Interactive comment on “Potential flood volume of Himalayan glacial lakes” by K. Fujita et al.

We thank the reviewer for his valuable comments. Our replies are denoted by a header [Reply].

Fig. 1. Figure R5. Cross sections along the outlet of five training glacial lakes in the Himalayas (see also Fig. 4).

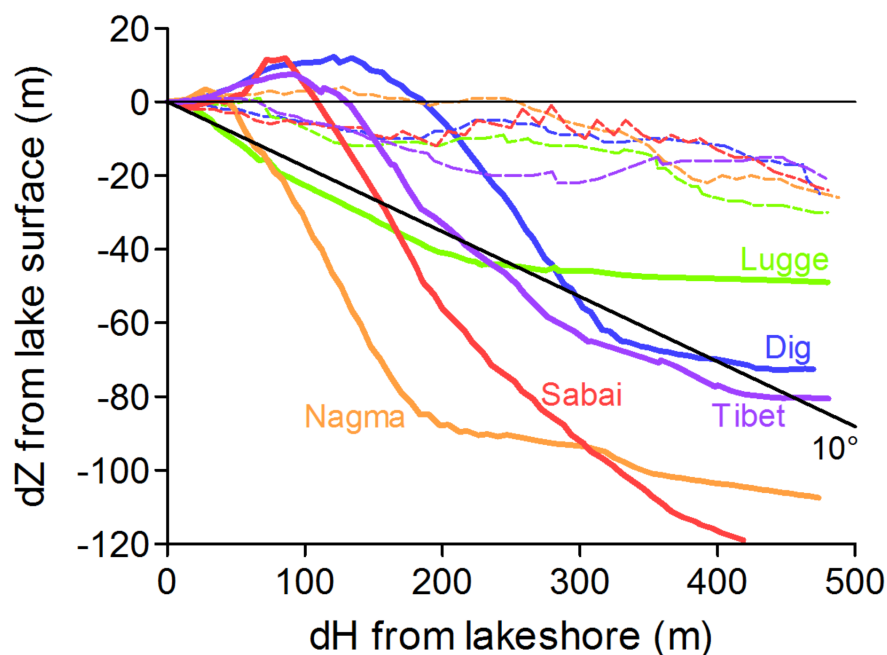
P20 l15-20 this is the crucial part where you derive the 10 degree threshold. Reformulate so that it is 100% clear how exactly you came to number 10 – at present it is not visible in Table 1. You could e.g. draw a figure where you would show a section across the moraines of these five lakes (in the style of Fig. 1) pre and post flood.

[Reply] We added a figure (Figure R5) for cross sections pre-/post-GLOF of the five lakes.
